## Product Change Notification – Klippon K Terminals box K1 type label change

PCN-PS27-20180413-01-ODRAP  
Published: 2018/04/13  
Validity: 2019/04/13  
Revision:1.0

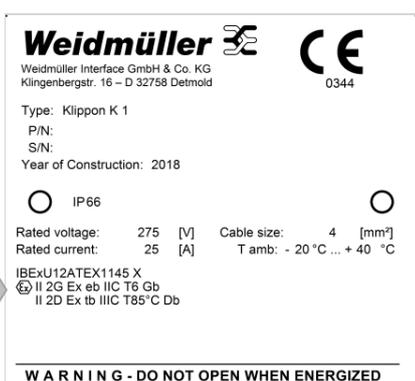
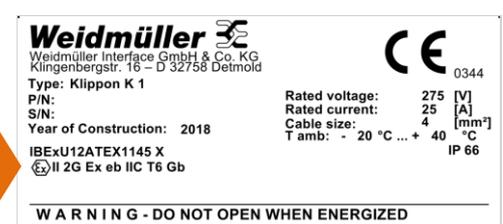
Due to the sizes of the enclosures, it is not possible to fix a standard approved stainless-steel label to the lid of the enclosure.

The further products will be supplied with a glued foil label, which is not allowed to use in dust applications.

According to this label change we also changed the marking, the following marking is now shown onto the type label:  $\text{Ex}$  II 2G Ex eb IIC T6 Gb. Note the below mentioned enclosures are for gas application used only.

- Changed from stainless steel label to foil label
- Use for gas application only! NO use for dust application any longer.
- Marking changed to  $\text{Ex}$  II 2G Ex eb IIC T6 Gb
